**Responses to  
the December 19, 2008  
Issues Resolution Workshop**

**Application for Certification  
(08-AFC-6)  
for  
WILLOW PASS  
GENERATING STATION  
Pittsburg, California**

February 2009

**FIGURE 4-1**

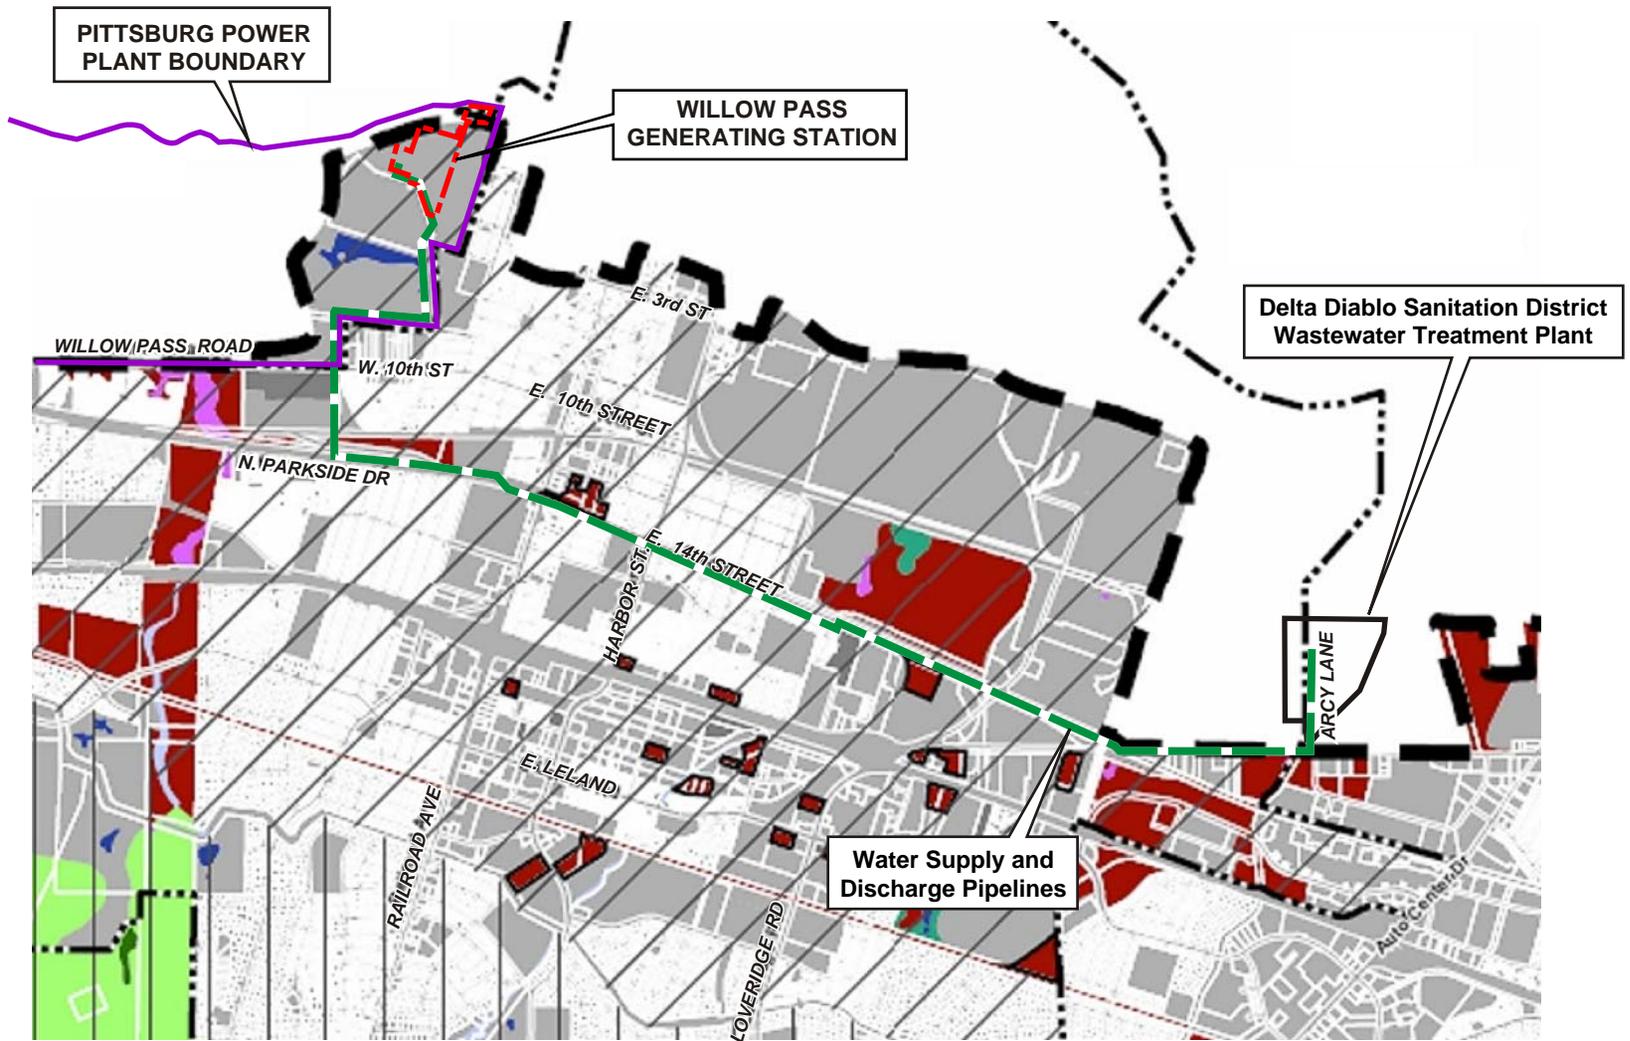
**4. Please discuss the East Contra Costa County Natural Community Conservation Plan, given that the project site and portions of the offsite linear fall within the City of Pittsburg.**

3. The Pittsburg Ordinance also states exemption for “Any development project that the City Planner determines is contained entirely within an area mapped as urban, turf, landfill and/or aqueduct land cover types in the HCP/NCCP, as generally depicted on Exhibit A...”

As defined in the Development Fee Zone Map of the Pittsburg Ordinance (attached as Figure 4-1), the WPGS and the offsite water supply and discharge pipelines will be constructed primarily within urban, developed areas. The one exception is the proposed offsite water pipelines alignment within the railroad switchyard, which is defined under the ordinance as ruderal habitat. Most impacts to this area will be avoided through the use of microtunneling; remaining impacts will be temporary in nature.
